Subject: Docket Number 070-03098
Duke Cogema Stone & Webster
Mixed Oxide Fuel Fabrication Facility
Seismology and Geotechnical Engineering Technical Exchange
Action Items

NRC Technical Exchange Seismology/Geotechnical Engineering (19-20 September 2001)

Action Item Followup

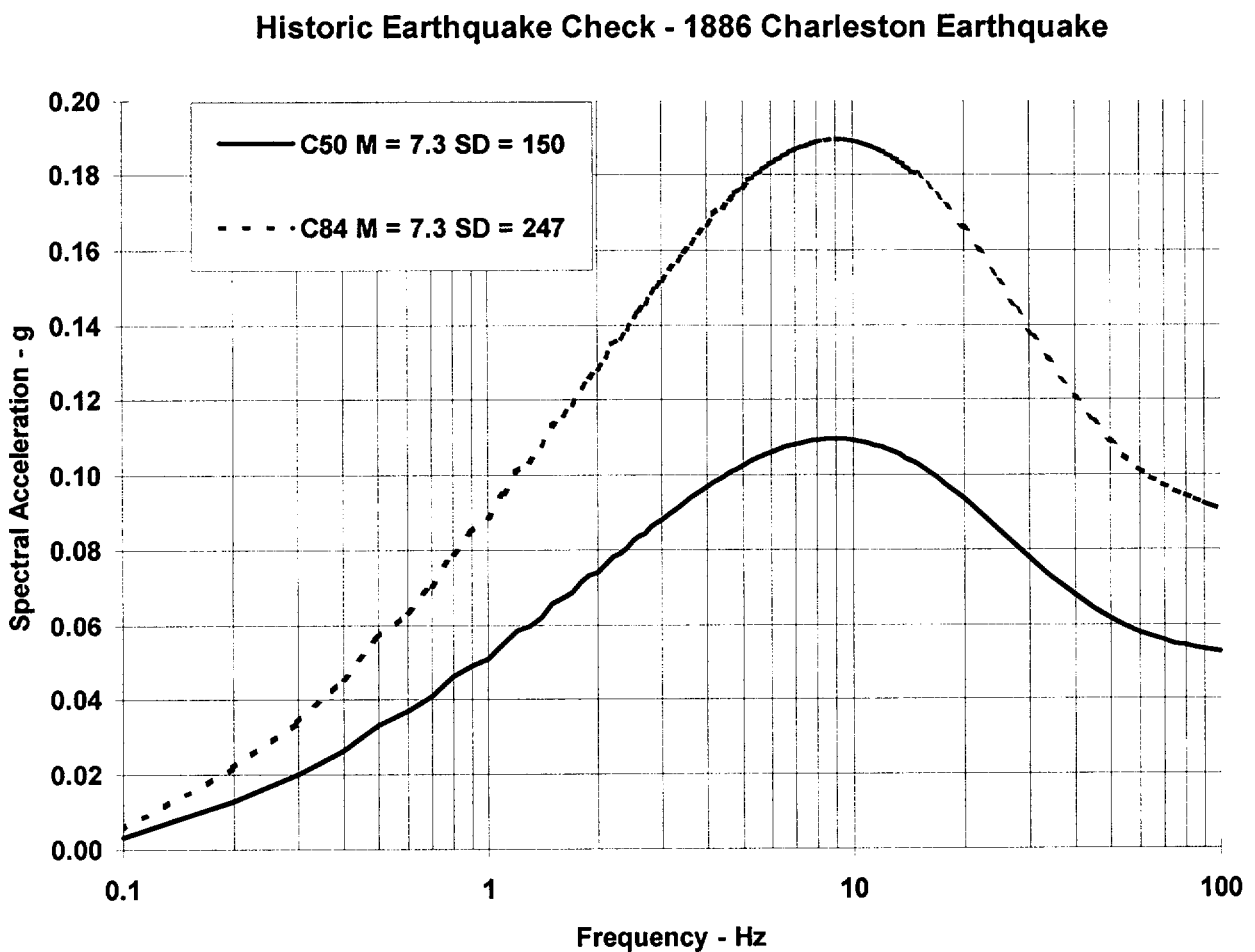
3. Confirm that the Woodstock fault is right lateral. Confirm that the dip on the Ashley River fault is almost vertical.

Confirm that the Woodstock Fault (WF) is right lateral:

- Page 1465, Paragraph 2 states, “The second set consists of 11 events with vertical fault planes and the others dipping to the west were oriented NNE-SSW and N-S, respectively. Segregation of these events into two subsets revealed that the subset IIA, oriented NNE-SSW was associated with **right-lateral strike slip motion on near vertical fault** and subset IIB oriented N-S with oblique faulting with a strong thrust component on a plane dipping about 41° W. These styles of faulting are in general agreement with the anticipated sense of motion on these faults in response to the orientation of S_{Hmax} . **These two subsets were classified as belonging to WF zone.**”
- Page 1443, Paragraph 3, Sentence 2 states, “**Composite fault plane solutions (CFPS) of other events suggested that the WF was associated with right-lateral strike slip motion...**”
